**SR-2 – STAFF ADVISORY REPORT (Rev. 03-11-2026)**

**ADDRESS:** 2050 ATKINSON

**APPLICATION NUMBER:** HDC2026-00729

**SCOPE:** REMOVE WOOD WINDOWS, INSTALL VINYL WINDOWS, REHABILITATE HOUSE  
(WORK STARTED WITHOUT APPROVAL)

*Left: Designation photo, 1984. HDAB.*

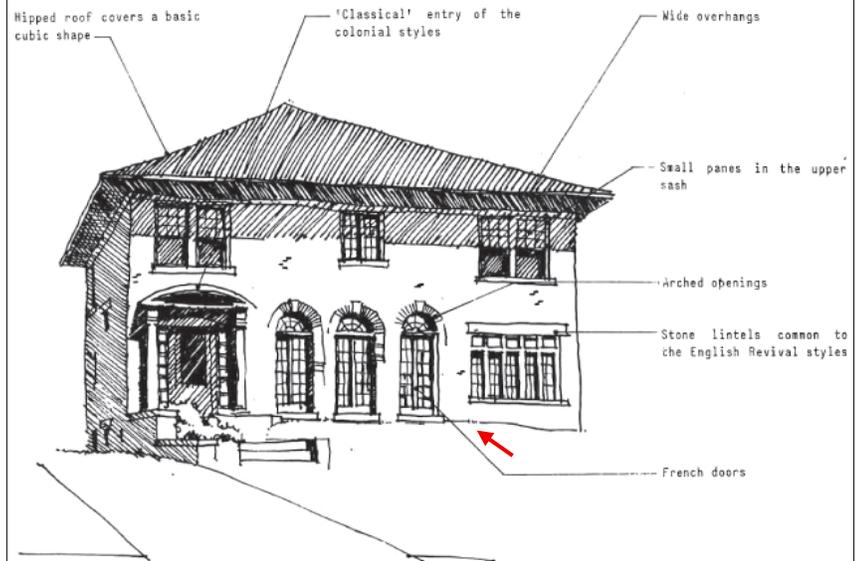
- “20<sup>th</sup> Century Composite” is the style that describes the dwelling within this application, as the identified features called out on the architectural description page (with exception of arched openings and stone lintels) were components of the original design.
- The raised lawn visible in the designation photo remains intact and is also depicted at the bottom of the French doors in the house sketch at right (from the HDC Architectural Styles-Color Guide). This landscape element is a distinctive character-defining feature of the property, equal in importance to the house’s distinctive features.

Left: Undated applicant photo, submitted to staff on 1/15/2026.

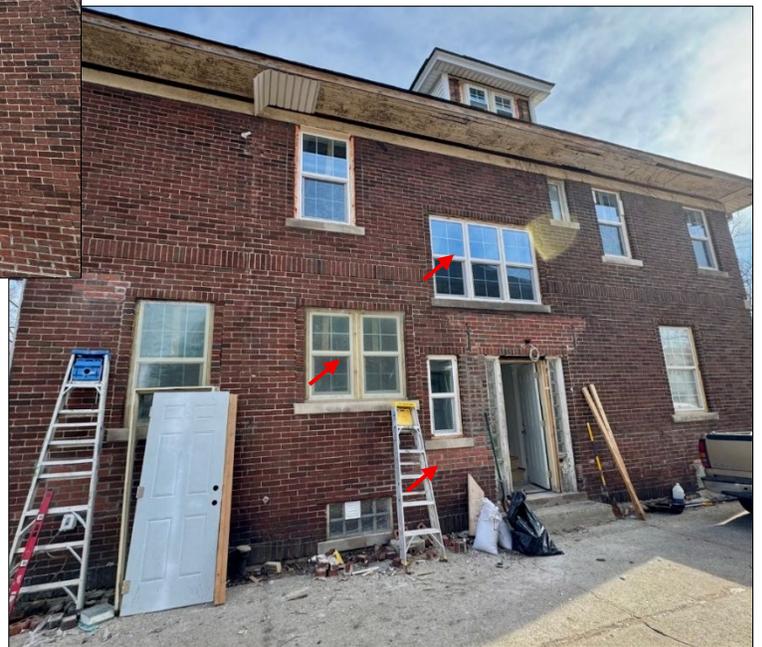
- Comparing the applicant's photo of the west wall and the photo staff took during the recent site visit, it is apparent that additional alterations were completed during the HDC review cycles and are not called out in the applicant's scope of work, specifically the reduction of the window opening adjacent to the front entrance, and removal of wood mullions in the 2- and 3-unit window openings.

Above, Staff photo, 2/26/2026 showing current condition of entry door.

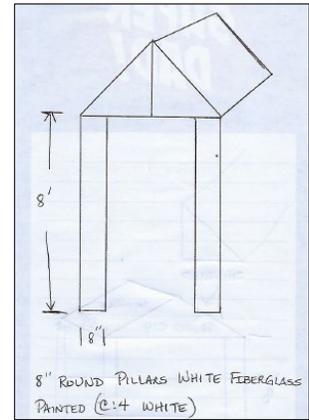
The depth of the historic mullions created a distinct separation between the multiple windows, whereas the new mullions are narrow and in plane with the windows, contemporizing the openings. It appears similar mullion replacement has been completed at window openings on other walls of the dwelling.

- Where the window was reduced in height, red brick was added to fill the remaining area of the original opening; the brick does not match the variegated brown and dark red colors of the historic brick. The original sidelights and panels of the main entry remain in place; however, the sidelight glass was replaced (at an unknown time) with glass block.

- The applicant's scope of work proposes replacing the non-historic door and historic sidelights with a factory mulled door and single sidelight.
- The roof structure for the portico is proposed to be a pitched roof (unspecified pitch), and the drawing suggests the columns will rest directly against the roof structure. This does not match the flat roof of the original design which replicated a Roman order, complete with frieze and cornice. Staff suggested the applicant use the designation photo and add dimensions for each component, as staff stated the requirement will likely be to match the components that were removed without approval.

Above: Staff photo, 02/26/26.

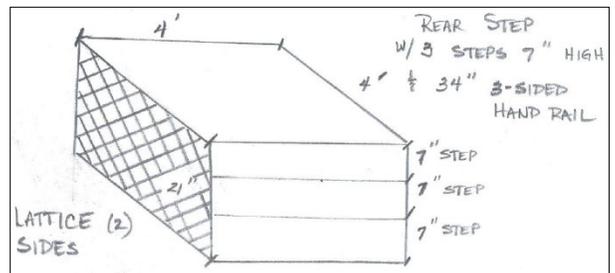
- The removal of the second story door and porch and replacement with a smaller window altered the features of this wing and removed the physical record of its time of construction and historic use.
- The drawing of a proposed first floor landing and stairs submitted by the applicant (Cycle 4) shows that it was to consist of a three step, 4'x4' landing and a “3-sided handrail”. Staff requested a drawing or photo of the proposed railing, but it has not been received. The landing under construction doesn't match the dimensions in the drawing, therefore a new

drawing must be submitted to reflect the current dimensions, design (including railing) and finishes – the applicant stated in one of the cycles the porch would be painted Yellowish-White (C:4). Additionally, diagonal lattice is a contemporary material and not compatible for use at a porch landing located at an entrance to an early 20<sup>th</sup>-century structure. Square lattice was used at this time, remains readily available, and would be a compatible material at this location.

1. The masonry cleaning will be comprised of a low-pressure hot water method (no chemicals), per the HDC's Masonry Cleaning Guidelines .
2. A photo of the selected design of the wood stair railing, along with a revised drawing of the porch and stairs accurate to the platform that is under construction, listing dimensions, materials and painted finish will be submitted for staff review.
3. Cut sheets for the gutters and downspouts, rear wing entry doors, and security doors will be submitted for staff review.
